DART AEROSPACE LTD		Work Order:	90378
Description: Support		Part Number:	D2896-1
Inspection Dwg: D2896	Rev: C	Page 1 of 1

D2896-1 SUPPORT

From: David Shepherd <dshepherd@dartaero.com>
Sent: Thursday, September 27, 2012 1:29 AM
To: 'Chris Provencal'
Cc: 'Mike Petsche'
Subject: RE: NCR D2896-1

RE: D2896-1 Support

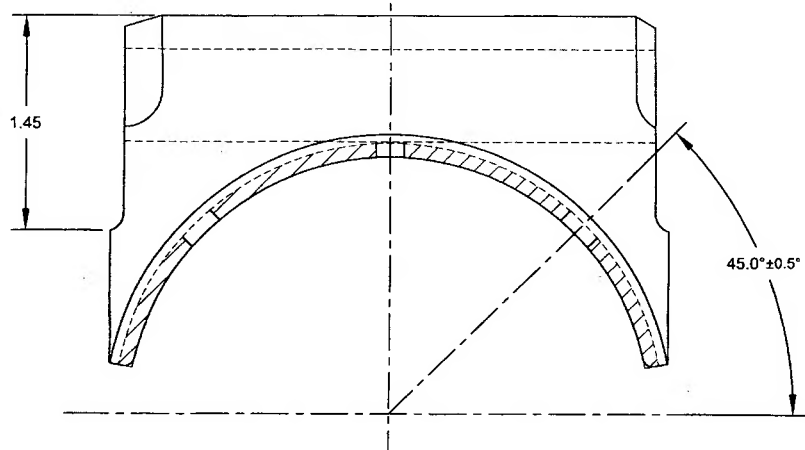
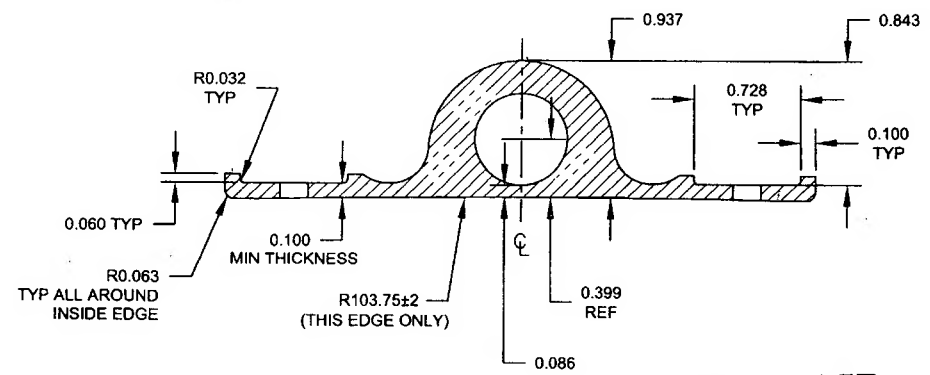
Root Cause	Date	Step	Qty	Description of work order update or Non-conformance	Initial Chief Eng	Action Description	Sign & Date	Verification	QC Inspector
Doc/Data <input checked="" type="checkbox"/>	12/9/27	100	2	Dimension 3.550 - 3.560 is 0.005 under tol. Ran the program with offset at 0 and part came out to short for dimension 3.555" R.C. Program Error.	DAS 12/9/27 12.09.27	SCRAP PER D.S. EMAIL. CRITICAL PART, ANY ALIGNMENT ISSUES COULD HAVE SERIOUS \$\$\$ CONSEQUENCES. Not replaced.	DAS 12/9/27 12.09.27	BA 12/10/03	DAS 1F 12/12/17
Equip/Tooling <input type="checkbox"/>									
Operator <input type="checkbox"/>									
Material <input type="checkbox"/>									
Setup <input type="checkbox"/>									
Other <input type="checkbox"/>									
Process <input type="checkbox"/>									
Supplier <input type="checkbox"/>									
Training <input type="checkbox"/>									
Unapproved <input type="checkbox"/>

Qty(2) supports, the width between attaching faces (3.550-3.560 dim) is 0.005 below tolerance (3.545). When installed in the rocker beam, this means the approx. 0.020 gap (checked with in-tolerance support) is a bit larger. The remaining dims are OK.

I know that you've been very strict with deviations on this aspect of the support in the past. I've scrapped similar supports in the past, but the deviation was much larger (0.015). I am inclined to scrap the parts as the tight tolerance is there for a reason (reduce potential problems with rocker beam alignment and its contact with the crosstube).

Is this deviation acceptable? Can we accept it based on successful assembly and test with the rocker beam?

If we are at all unsure, it is better to scrap the part.

I think the point is that an extra 0.005" gap at the support will allow the rocker beam to be misaligned by an additional $14 \times 0.005" = 0.070"$ at the chafing shields, which is NOT insignificant.
